Docket No. FAA-2012-0662; Airspace Docket No. 08-AWA-2

Proposed Modification of Class B Airspace Area; Philadelphia, PA

ACTION: Notice of proposed rulemaking (NPRM).

PROPOSED MODIFICATION OF THE
PHILADELPHIA, PA, CLASS B AIRSPACE AREA
(Airspace Docket No. 08-AWA-2)

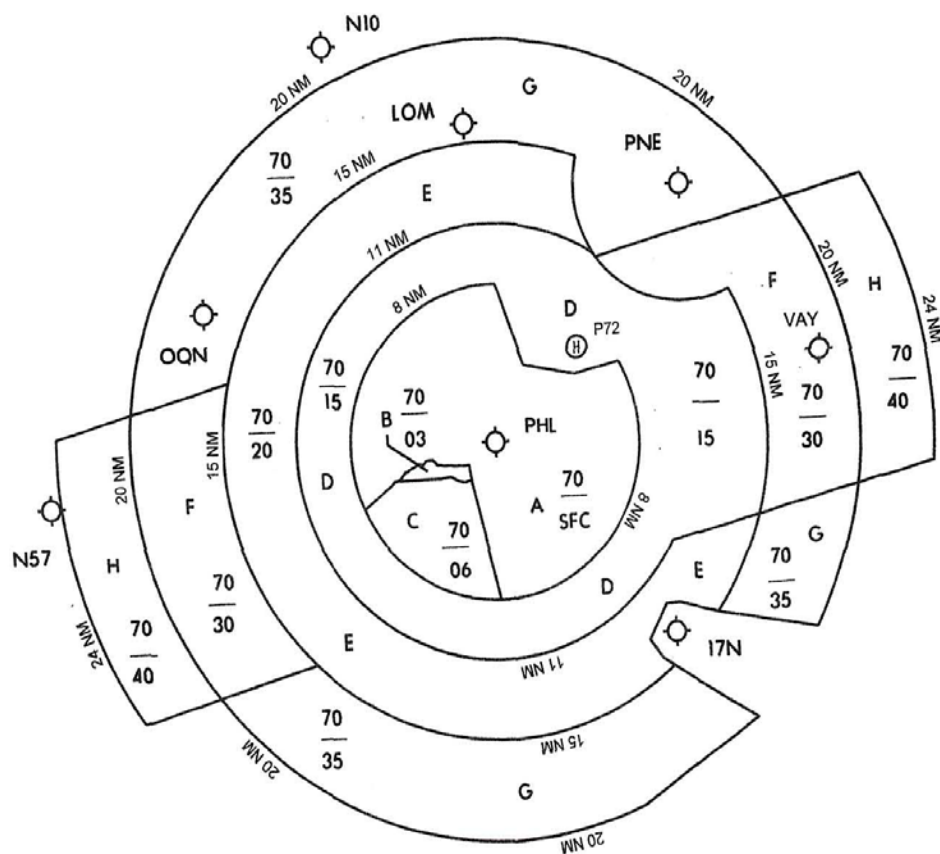
The Committee asked that the surface area cutout be expanded to include Cooper Hospital and Penn's Landing Heliport (P72) to allow Medevac helicopter operations below 1,500 feet, and that an additional ring be created from 6 miles to 8 miles with a 1,000 foot floor so that flights from the Pottstown area could navigate to the Philadelphia center city hospital areas without entering Class B airspace.

The Committee said that the proposed cutout for Cross Keys Airport (17N) should be widened to allow VFR traffic to operate in a corridor that provides sufficient access to the airport without encroaching on skydiving operations.

The Committee suggested a cutout south of Wings Field Airport (LOM) to allow aircraft entering the traffic pattern from the north to cross over the airport at 2,500 feet then descend to traffic pattern altitude. The Committee also noted that VFR aircraft maneuvering south of LOM must be below 2,000 feet to remain below the proposed Class B floor in that area, which could result in compression and concern about the 1,600-foot towers nearby.

The Committee asked for a cutout east of New Garden Airport (N57) to allow glider operations to continue.

The Committee said a corridor should be adopted to allow general aviation aircraft flying VFR from the west or northwest of Philadelphia to transit the Class B airspace with some predictability when en route to southeast and southern New Jersey.

The Committee proposed that a “key hole”, or Runway 24 departure corridor, be established to enable aircraft departing Trenton Mercer Airport (TTN) to climb at a more expeditious rate prior to entering Class B airspace. Also, the use of Continuous Descent Approaches (CDA) for TTN arrivals to Runway 6 should be considered.

The Committee opposed the expansion of the surface area radius to 8 miles because it

The Committee requested a cutout around Perkiomen Valley Airport (N10) to accommodate flight school and skydive operations.

The Committee provided an alternative proposed Class B design, prepared by the Aircraft Owners and Pilots Association (AOPA). AOPA contended that the FAA's preliminary design appeared overly complex with multiple floors and sectors as well as being larger than needed to contain arriving and departing aircraft.

Two commenters contended that the proposed expansion of the surface area from 6 miles to 8 miles was not adequately justified, would result in compression of VFR traffic operating below the Class B floor, would cause the boundary to be difficult to identify visually.

Several commenters requested either a cutout around Brandywine Airport (OQN) or that the Class B floor above OQN remain at 4,000 feet.

Seven commenters had concerns about the effect of the proposal on glider operations at New Garden Airport (N57). A 5-mile cutout around N57 was requested.

Ten commenters were concerned about the potential for compression of traffic and inadvertent Class B intrusions near Wings Field Airport (LOM) and suggested that the Class B floor over LOM be kept at 4,000 feet; the proposed 2,000-foot floor, south of LOM, be raised to 2,500 feet or 3,000 feet; and/or a cutout around LOM be created.

Nine commenters suggested changes on behalf of the following airports located to the east and south of PHL: South Jersey Regional (VAY), Flying W (N14), Red Lion (N73); and Cross Keys (17N). Issues raised included: simplifying the design by changing the 3,500-foot floor northeast of the 17N airport “cutout” to either 3,000 feet or 4,000 feet to combine with adjacent areas, making the cutout for 17N larger, compression of VFR traffic, and creating a corridor similar to that in the Los Angeles, CA Class B airspace area.

Six commenters suggested changes on the east and south sides of the proposed Class B, including: raise the Class B floor or create a cutout over VAY, N14 and N73; modify the Class B north of the 17N cutout so that the direct route between McGuire VORTAC (GXU) and Cedar Lake VORTAC (VCN) does not create nose-to-nose VFR traffic at 3,000 feet; and expand the "funnel" between Robbinsville VORTAC (RBV) and VCN between the Class B boundary and Alert Area A-220 to prevent compression of VFR traffic.

One commenter suggested the DME distances should be published to identify the Class B rings.

One commenter was concerned that the Tabernacle, NJ practice area would not be usable for certain training maneuvers if it was under Class B airspace.

A number of commenters stated that there are too many Class B floor variations in the proposed design which would be confusing to pilots and it would be difficult to determine the boundaries without GPS navigation equipment on board. Further, this could cause compression underneath the Class B.

One commenter proposed that the extensions on the east and west be made part-time so that they would only be active when actually being used for traffic containment.

One commenter contended that the need for lower Class B floors could be reduced by eliminating the requirement for aircraft to be below the ILS glideslope when being turned on to final approach and by using a two-stage glide slope set at 3 degrees within 8 to 9 miles from the runway and up to 6 degrees at greater distances.

The FAA expanded the proposed cutout northeast of PHL to include both Cooper Hospital and Penn's Landing heliports. A direct route of flight from the Pottstown area to center city Philadelphia is almost completely outside of the proposed Class B airspace. A 1,000-foot

ring between 6 and 8 miles is unnecessary because aircraft flying from the Pottstown area to downtown Philadelphia could remain outside the proposed Class B with only a small correction to the east.

The proposed cutout has been reconfigured to allow for skydiving and access for VFR aircraft arriving from or departing to the southeast.

Currently, the floor of Class B airspace just to the south of LOM is 3,000 feet. The proposed modifications would lower that floor to 2,000 feet. We are unable to create a cutout south of LOM because that portion of the proposed Class B is designed to protect aircraft being vectored for the ILS approach to Runway 17 at PHL. Today, aircraft inbound to PHL in this area are routinely vectored to join the ILS localizer at altitudes between 2,000 and 2,500 feet. There would be just over 1 mile available for aircraft approaching LOM from the north and northwest to cross over LOM at 2,500 feet and descend to enter the local traffic pattern without entering the Class B airspace. The requested cutout south of LOM would not allow enough room to keep the Runway 17 arrivals within Class B airspace. The towers referenced above

(known as the Roxboro Antennas) are located 7.5 miles south-southeast of LOM and should not be a factor.

While N57 lies well outside the existing 20-mile ring of the Class B airspace area, the proposed modification would extend the Class B airspace boundary out to 24 miles (which would lie just to the east of N57) with a floor of 4,000 feet. N57 is located under an area where a significant amount of commercial traffic is routed on a daily basis. When PHL is on an east operation, aircraft landing Runway 9R are operating in the immediate vicinity of N57. The Runway 9R arrivals from the north and south are handed off to the Final Vector (FV) controller who sequences and spaces these aircraft for landing. To accomplish this, the FV controller vectors and descends the arriving aircraft, blending the two feeds into one. FAA directives require that the aircraft be retained within Class B airspace during this process, but the current Class B configuration does not extend far enough to the west for controllers to comply with this requirement. The requested cutout east of N57 cannot be accommodated because it would not provide sufficient airspace to allow controllers to keep PHL arrivals within Class B airspace.

The FAA raised the proposed Class B floor in the majority of the 15-mile to 20-mile ring to 3,500 feet. However, two sections between 15 miles and 20 miles (one on the east side and the other on the west side), would still have a 3,000-foot floor. These two 3,000-foot areas are

essential for containing aircraft on the ILS approaches to the primary runways. Due to the 3,000-foot areas, pilots would still need to make a small route change when transitioning to or from the north or south, but setting the proposed floor at 3,500 feet in the remainder of the 15-mile to 20-mile ring would allow greater flexibility for general aviation aircraft operating around Philadelphia. Regarding VFR services, the FAA encourages VFR aircraft to contact PHL and request flight following, advisory and/or Class B separation services. This would allow these aircraft to operate at higher altitudes. PHL Airport Traffic Control Tower (ATCT) has made a commitment to the user community to plan for and staff to provide services to aircraft potentially impacted by the proposed changes to the Class B.

TTN currently is, and would remain, well outside the proposed Class B airspace. The FAA believes that the proposed Class B configuration would allow sufficient opportunity (approximately 7 miles) for aircraft departing TTN Runway 24 to either contact Philadelphia approach for Class B clearance or avoid the airspace. CDAs are not operationally feasible in the TTN area. These IFR procedures allow for a continuous descent from an enroute or high initial approach altitude to the runway. ATC sectorization (both inter-facility and intra-facility) in the area northeast of PHL does not allow any procedures (CDAs or Optimized Profile Descents - OPD) that require steep, unrestricted descents.

would place the Commodore Barry Bridge (which serves as a landmark used by pilots to stay outside the Class B airspace) within Class B airspace. In addition, the 8-mile ring would place the Pier 36 heliport inside the surface area.

The airspace in this area is required to contain PHL arrivals on the ILS to Runways 9R and 9L. While the proposed 8-mile ring would encompass the bridge, VFR pilots could still use the bridge as a landmark but would have to visually remain 2 miles west of the bridge to avoid the Class B airspace. The expanded ring would also protect small aircraft from possible wake turbulence caused by large and heavy jet aircraft landing Runway 9R. The proposal has been revised so that Pier 36 would be included in the cutout to the northeast of PHL. Helicopters approaching downtown Philadelphia from the west would be required to either obtain a Class B clearance or circumnavigate the airspace as they do today.

The preliminary Class B design proposed to expand Class B airspace out to a 24-mile ring. This would have resulted in Class B airspace being established above N10 from 4,000 feet up to 7,000 feet. The FAA reevaluated the need for the 24-mile ring, and decided to propose expanding to 24 miles on only east and west ends in order to encompass the extended finals to the primary runways at PHL. Therefore, the outer boundary of Class B airspace would remain at 20 miles in the vicinity of N10 as it is today.

As previously noted, the FAA changed the proposal remove to the 24-mile ring, except on the east and west ends. However, the alternative design's higher floors and reduced eastern boundary would not meet the need for containing aircraft on ILS approaches to the primary runways. The alternative design's 5,000-foot Class B floor to the east and west of the airport would not provide enough altitudes to separate aircraft on opposing base legs. In both areas, 4,000 feet and 5,000 feet must be available for controllers to comply with the vertical separation requirements while aircraft are on opposing base legs (i.e., head-on). Class B airspace also must be extended and lowered to the south of PHL to contain aircraft being vectored to Runway 35. With the increased usage of that runway, the final approach routinely extends beyond 15 miles.

This issue was discussed, in part, in the “Ad hoc Committee” section, above. The expansion to 8 miles is necessary because some VFR operations are conducted beneath the final approach courses at locations and altitudes that are causing Traffic Alert and Collision Avoidance System (TCAS) Resolution Advisories (RAs) which cause arriving aircraft to execute unplanned missed approaches. Although the proposed cutout from the surface area was expanded northeast of PHL in response to Ad Hoc Committee input, the alignment of PHL’s runways (09/27 and 17/35) makes an 8 mile surface area necessary to protect the final approach courses to those runways.

It is necessary to lower the floor of the 20-mile ring (over OQN) from 4,000 feet to 3,500 feet, and the floor of the 15-mile ring (east of OQN), from 3,000 feet to 2,000 feet to contain arrivals landing Runway 9L as they descend on base leg for approach to PHL.

The proposed Class B extension to 24 miles would place the boundary just east of N57, with a floor of 4,000 feet. This airspace is needed to contain arrivals when PHL is on an east operation. Philadelphia ATC personnel are discussing with the users of N57 the possibility of developing procedures via a Letter of Agreement that would minimize the impact of the Class B

change on their operation.

The proposed Class B airspace in the vicinity of LOM is intended to contain aircraft executing the ILS Runway 17 approach at PHL. These arrivals cross a point about 14 NM north of PHL at 3,000 feet, and descend on the glide path for Runway 17. VFR aircraft arriving at LOM currently overfly the airport at 2,500 feet then enter a left traffic pattern for Runway 24. These aircraft pose a potential conflict with PHL Runway 17 arrivals. PHL ATCT encourages VFR aircraft to contact PHL and request flight following, traffic advisories and/or Class B separation services. This would allow these aircraft to operate at higher altitudes. PHL ATCT has made a commitment to the user community to plan for, and staff to provide services to aircraft impacted by the changes to the Class B.

The proposed 17N cutout has been slightly expanded from the design presented at the informal airspace meetings, but it could not be further expanded without having an impact on

traffic flows inside the Class B. Raising the floor to 4,000 feet would not be sufficient to contain arriving aircraft within Class B airspace, while a 3,000-foot floor would be more restrictive than needed to contain those aircraft. The proposal's 3,500-foot floor provides adequate protection for PHL arrivals while minimizing the impact on VFR traffic. The volume and flow of traffic at PHL preclude the development of a corridor like the one through the Los Angeles Class B airspace area. However, VFR flyways under and around the airspace would be developed as part of the proposed Class B modification.

The FAA understands that the proposed changes would reduce the amount of airspace available for VFR operations southeast of the PHL Class B. To lessen this impact, the 24-mile ring has been reduced in size as discussed previously. However, because VAY, N14 and N73 all lie within 24 miles of PHL, as well as in the arrival area, and less than 4 miles from the final approach course, it is not possible to create a cutout or raise the proposed Class B floor over those airports without a significant impact on PHL arrivals. PHL ATC would provide clearance through the Class B airspace to VFR flights whenever possible. In addition, traffic from PNE and TTN that transitions PHL airspace to points in South Jersey represents a large number of the conflicts with arrival traffic to Runways 26 and 27R. As such, the VFR corridor designed,

more than 25 years ago, is no longer viable. It is PHL ATCT's expectation that this traffic would contact PHL ATCT for flight-following and/or Class B separation services, thus providing a safer environment for all users of the ATC system. VFR aircraft wishing to transit the portion of Alert Area A-220 that would fall within the proposed Class B airspace would be under the control of ATC and therefore would receive separation services from any military aircraft. Pilots that choose to either circumnavigate the area, or fly at altitudes below the Class B airspace, could operate pretty much as they do today except at slightly lower altitudes. The possibility of developing charted routes through the Class B would be considered as a way to mitigate the potential compression issues identified by the commenters.

The distances depicted in this proposal are measured from the PHL Airport Reference Point (ARP) defined as lat. 39°52'20"N., long. 75°14'27"W. The lack of a VOR/DME facility at PHL, upon which to base radials and DME distances, limits the options for describing the airspace. There are six ILSs with DME at PHL. The FAA will explore the possibility of publishing an alternate description using ILS/DME distances on the PHL VFR Terminal Area chart with an explanation of how to use the DME distances as a guide for navigating around the area.

The smaller proposed 24-mile Class B extension would not completely remove the practice area from under Class B airspace; however, no additional adjustments could be made in

that area without impacting PHL arrivals. Users of the practice area should be able to get a Class B clearance when PHL is on an east operation and that airspace is not in use for arrivals.

Simplicity is a goal of airspace design and it is true that using one altitude for the entire circle would be less complex. However, the proposed 3,000-foot floor on the east and west sides could not be raised to 3,500 feet, as some suggested, without impacting PHL arrivals because this airspace is necessary to contain aircraft descending to land at PHL. Lowering the floor to 3,000 feet all the way around for simplicity would create additional impact on VFR operations by designating Class B airspace where a 3,000-foot floor is not required by ATC. The FAA understands the need of VFR pilots to have access to Class B airspace for safety and efficiency of flight, and plans to make this available on request whenever it can be provided without impacting the safety of other aircraft operating in the airspace.

The suggestion for part-time Class B segments could potentially decrease the impact on nonparticipating traffic. A similar concept has been successfully applied to military special use airspace areas. However, further study of various issues is required to determine whether the concept is operationally feasible and could be safely implemented in a Class B airspace environment. These issues include: procedures for activating/deactivating affected Class B

sections and ensuring real-time pilot notification of airspace status changes, response to runway changes or closures and inflight emergencies, aeronautical charting specifications, weather factors, safety; etc.

These suggestions would require a revision of instrument flight procedures and the development of new or additional glideslope equipment which may not be technically feasible and/or may involve flight safety issues. As such, they are outside the scope of this airspace proposal.
